BOARD OF APPEALS, CITY & COUNTY OF SAN FRANCISCO

Appeal No. **22-008**

NOTICE OF APPEAL

The substance or effect of the decision or order appealed from is the ISSUANCE on February 7, 2022 to Salo Rawet and David Gellman, of an Alteration Permit (concrete retaining wall to property line to maintain existing grade five feet by five inches; revision to Permit Application No. 2021/0570/0002) at 405 Duncan Street.

SITE PLAN & DETAILS

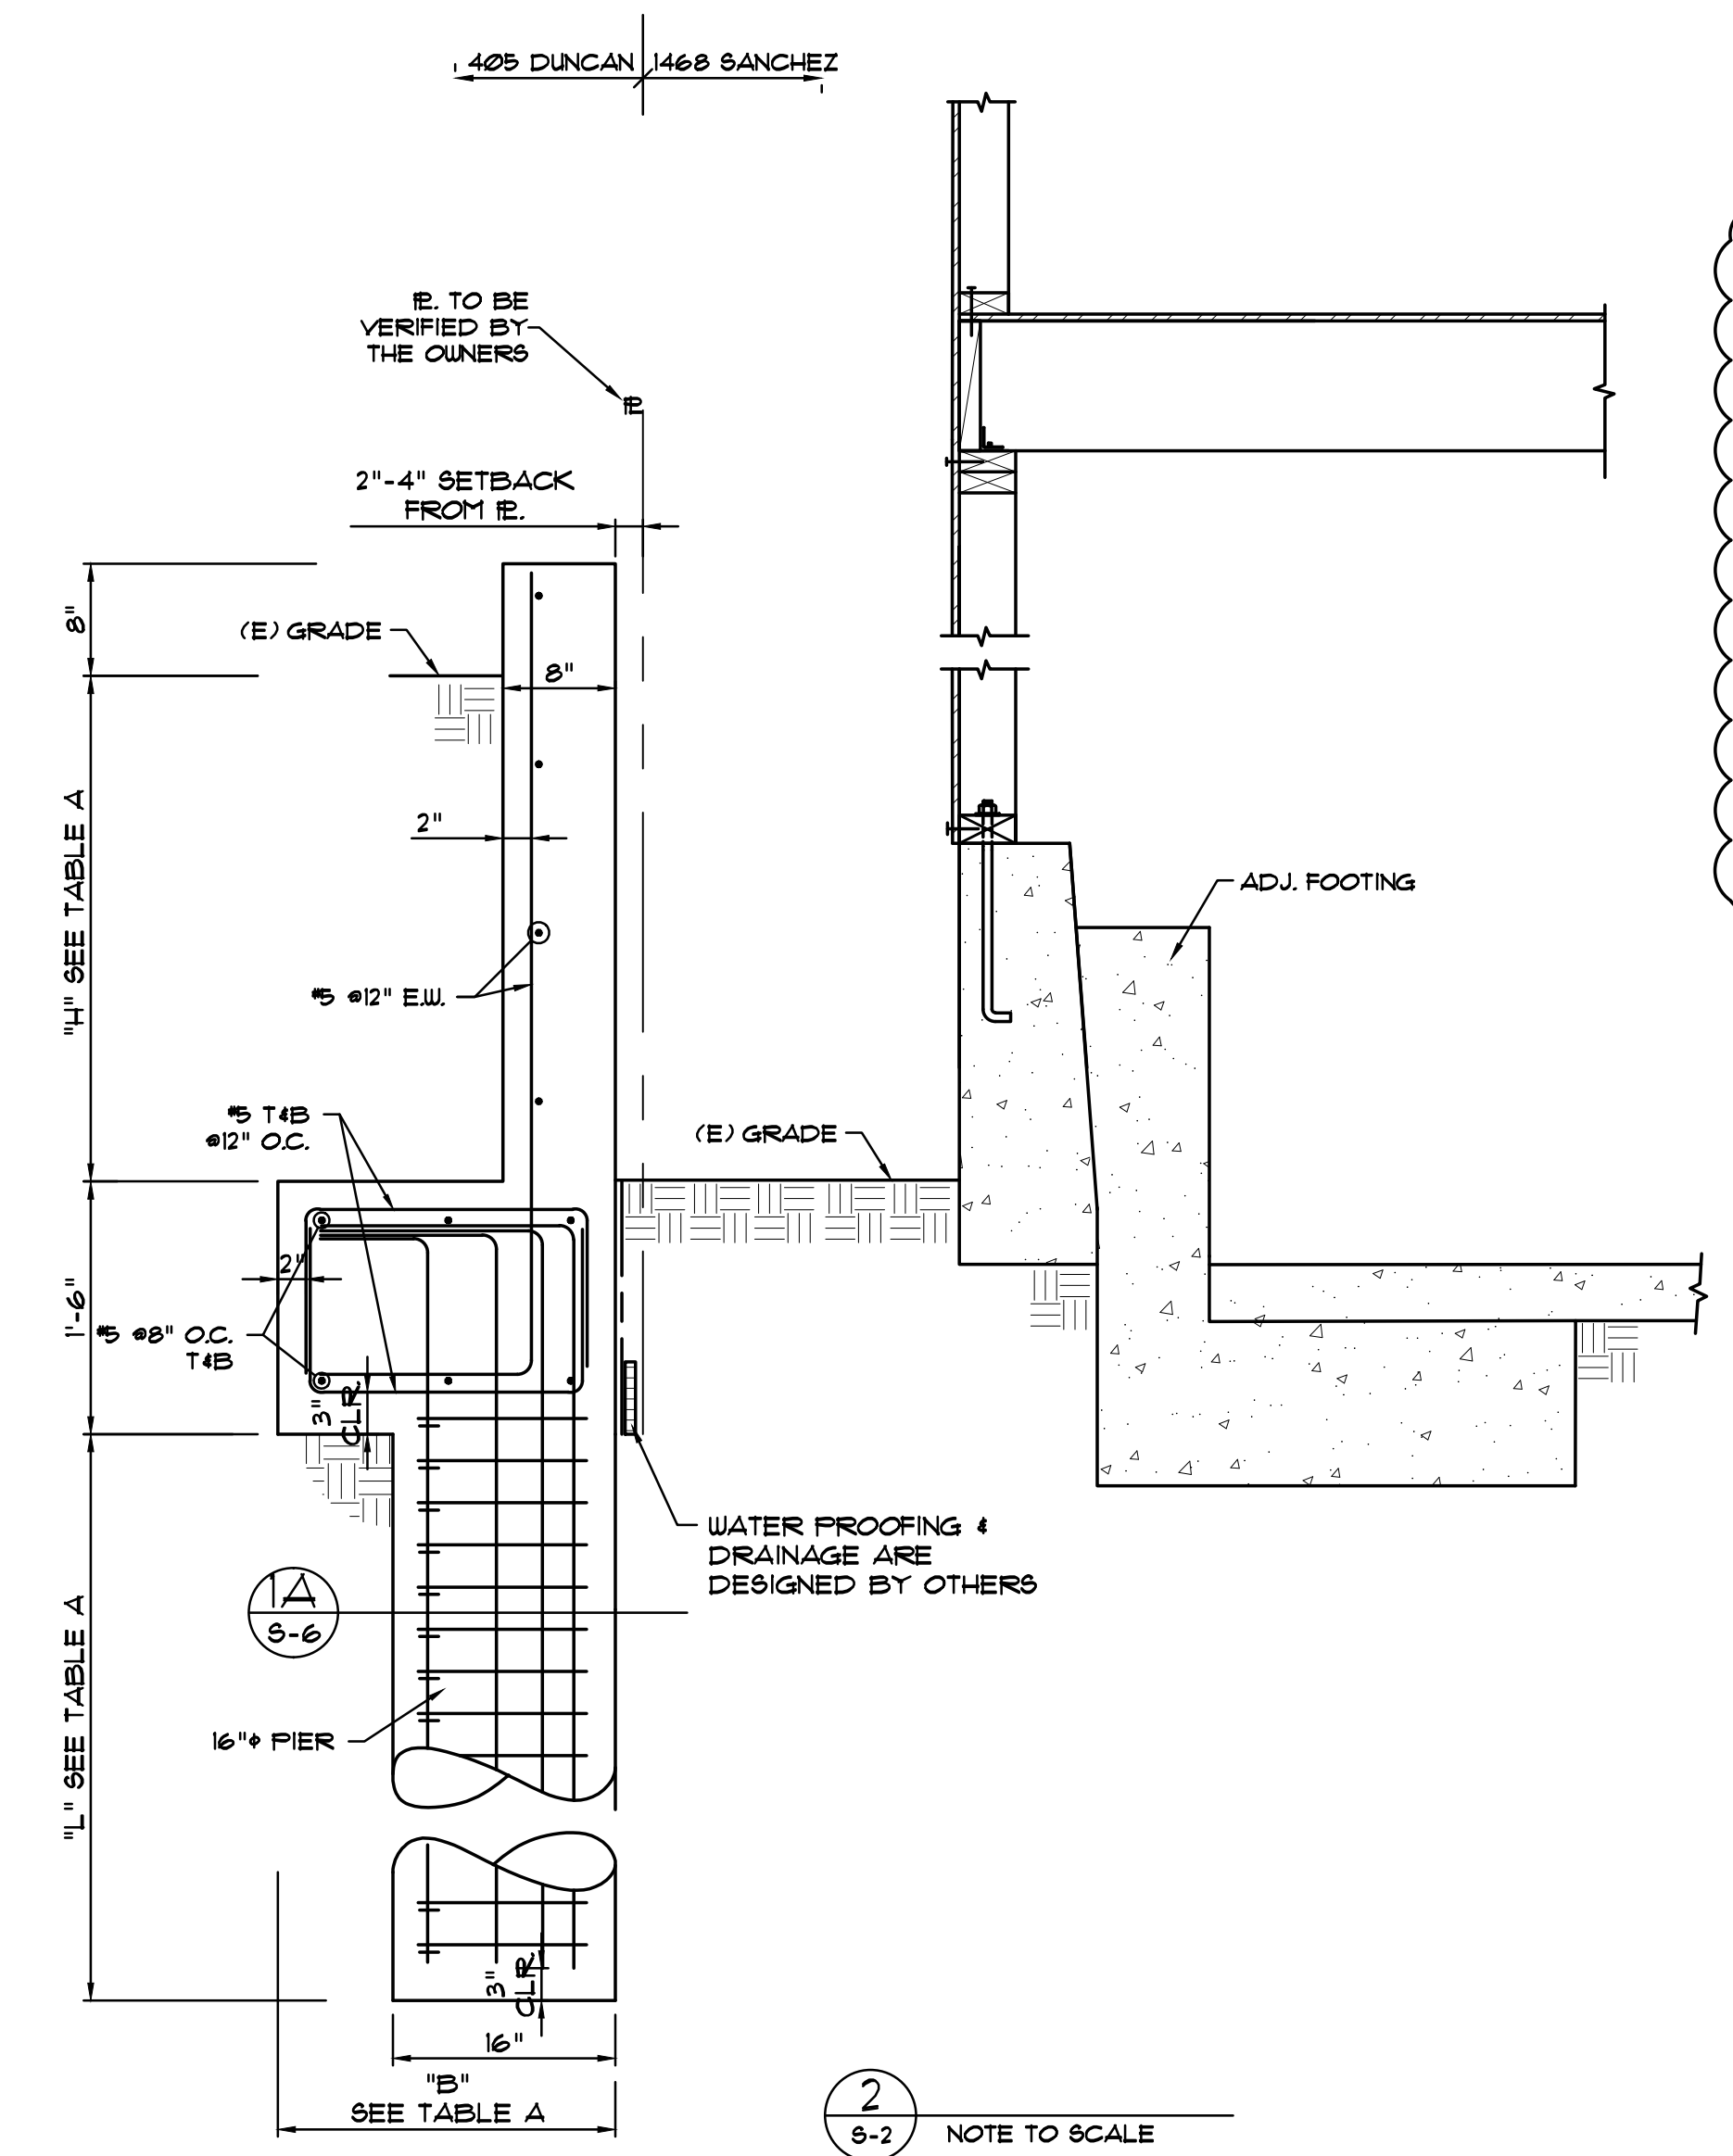
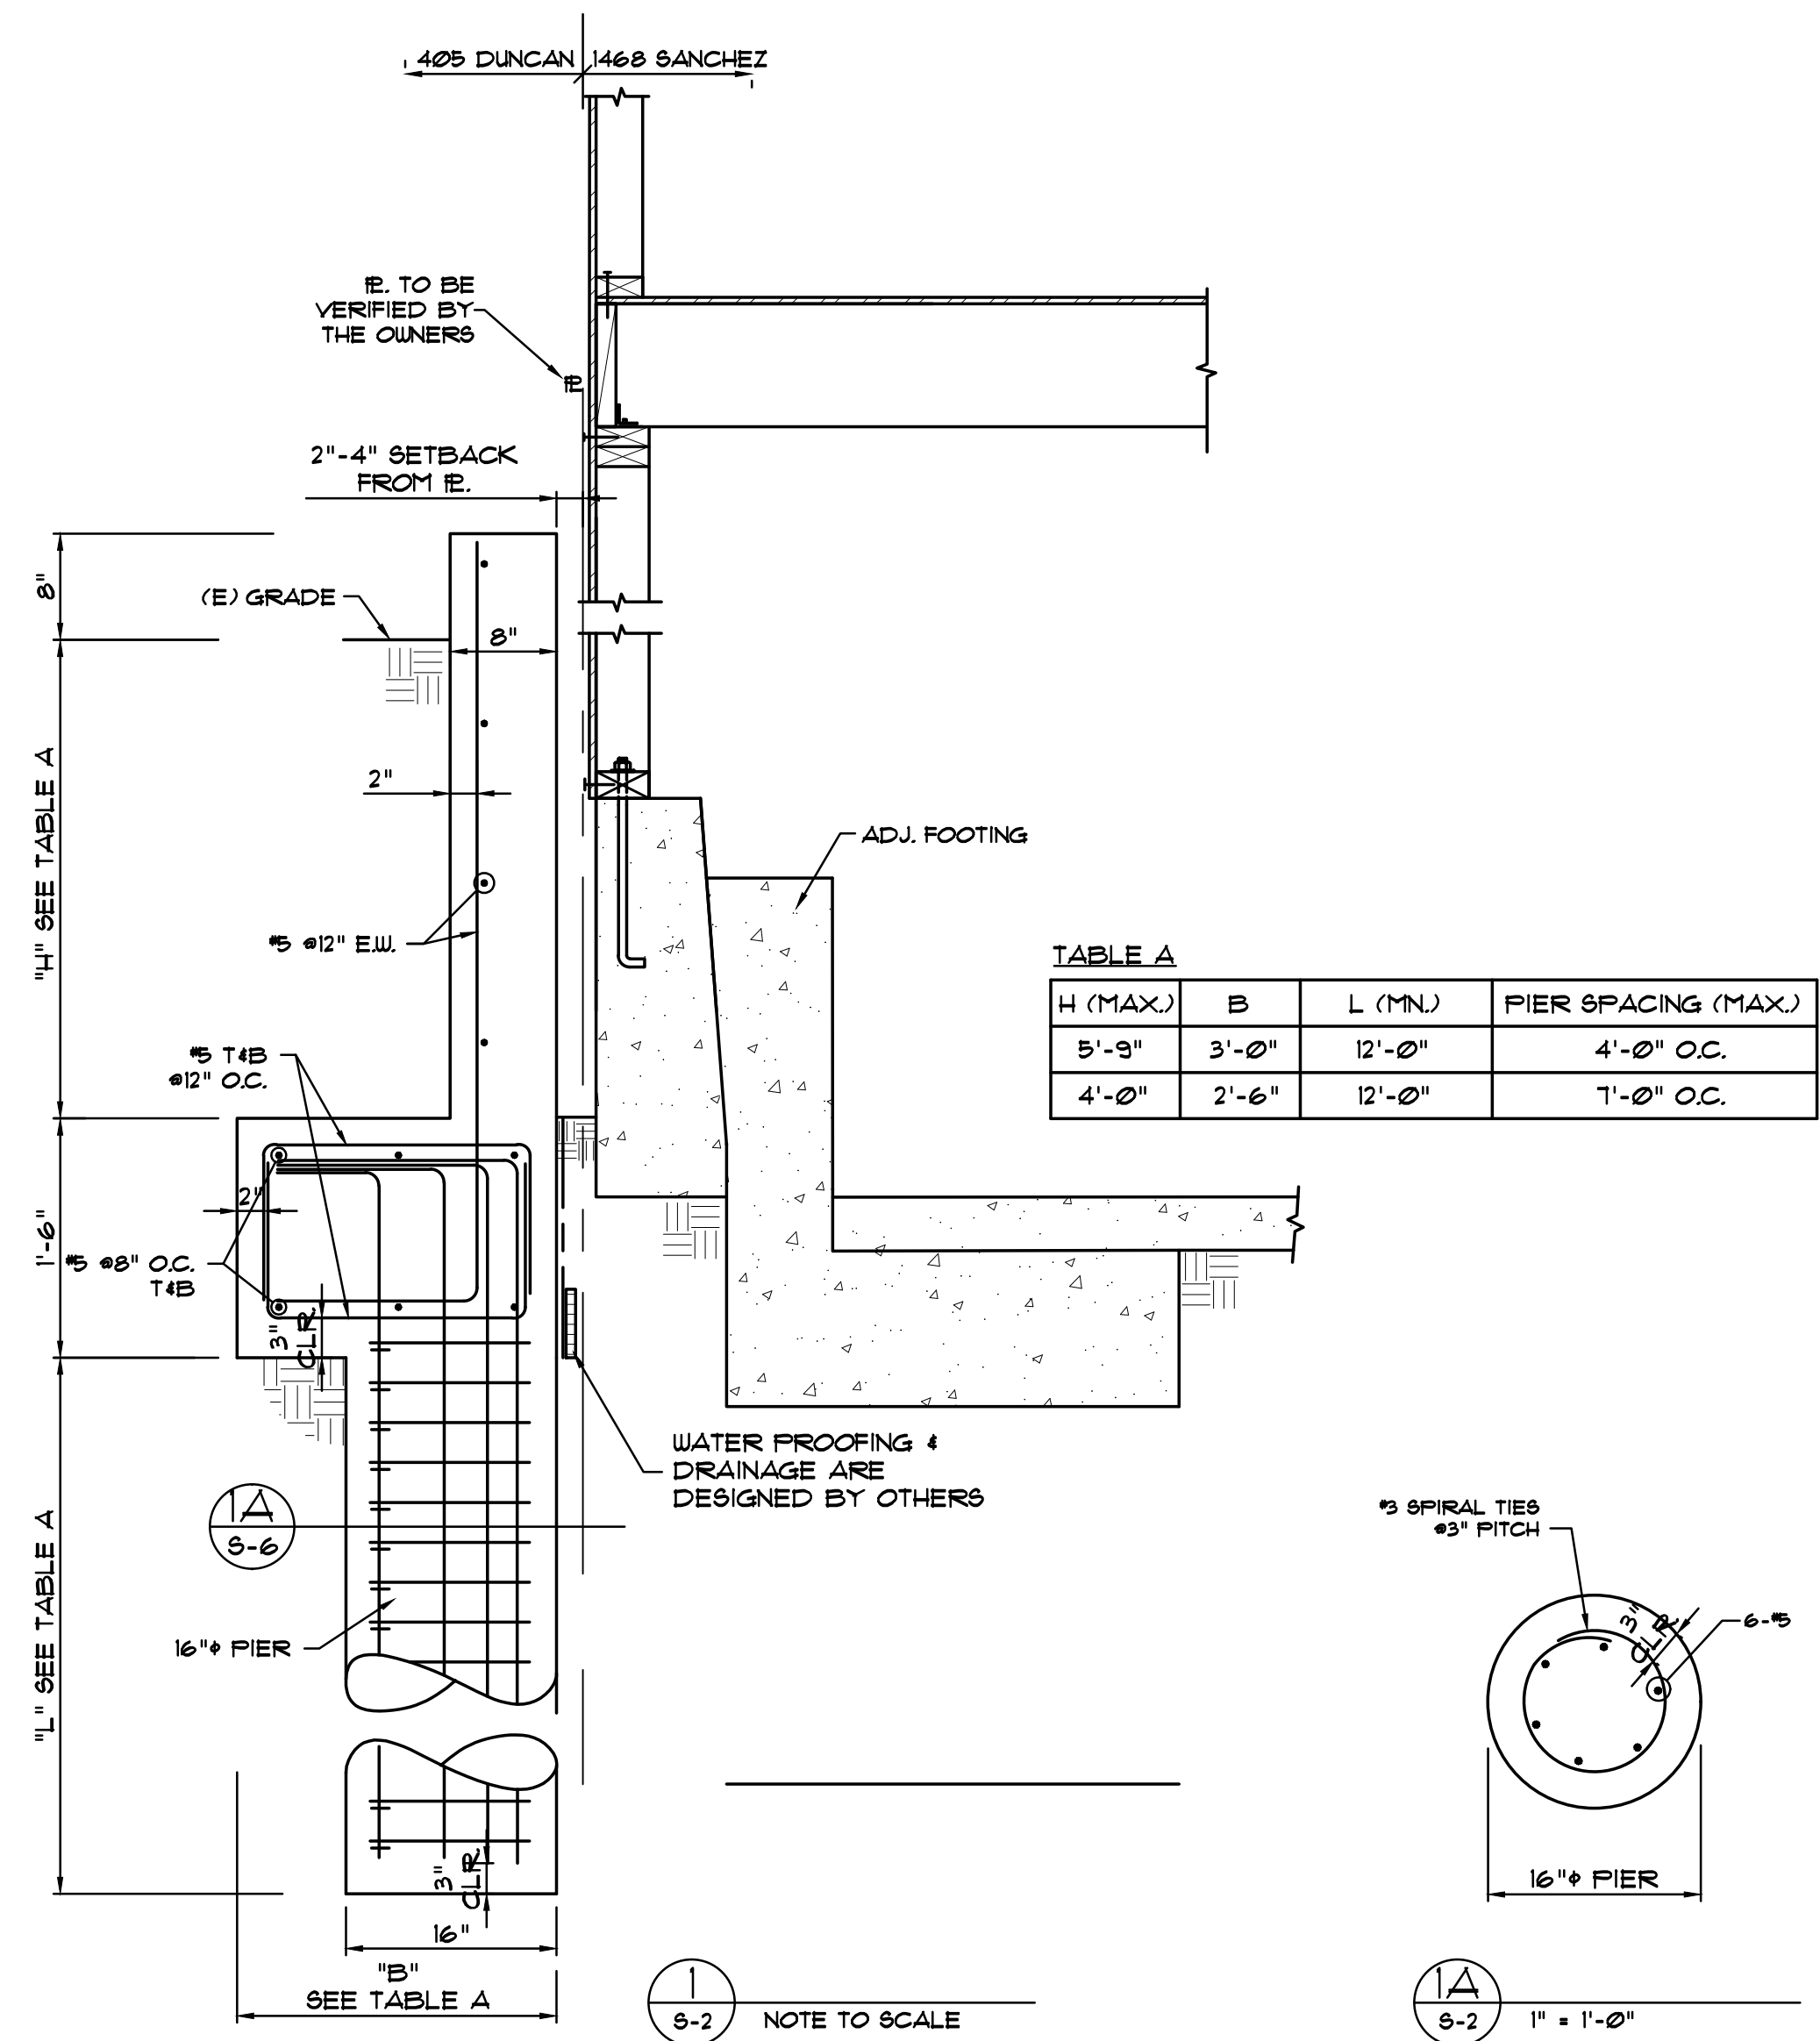
The S-2 plan sheet shows details of the retaining wall with 2 cross sections. However, there was no information on the drainage of the 405 Duncan Street yard nor any waterproofing details. Here are comments based on my review of the S-2 drawing you have provided so far:

- A drainage system that moves all surface water from the yard into the public street without entering onto other private property must be added. Based on my site observation along with this one plan sheet, the rear yard of 405 Duncan Street appears to have no existing drainage system that will move any surface water to the public street without traversing thru another private property, specifically my client's property, 1468 Sanchez Street.

- The S-2 Sheet proposes a drainage system on the outside of the grade beam. It doesn't show the system connected and a means to move the water into the public street.

I see in your notes that you “have no responsibility for waterproofing and drainage” and that these will be “designed by others.” Have your clients retained a licensed engineer [with specific drainage system expertise](#) to address these issues and provide designs for waterproofing and drainage, and do you know when they will be available to review?
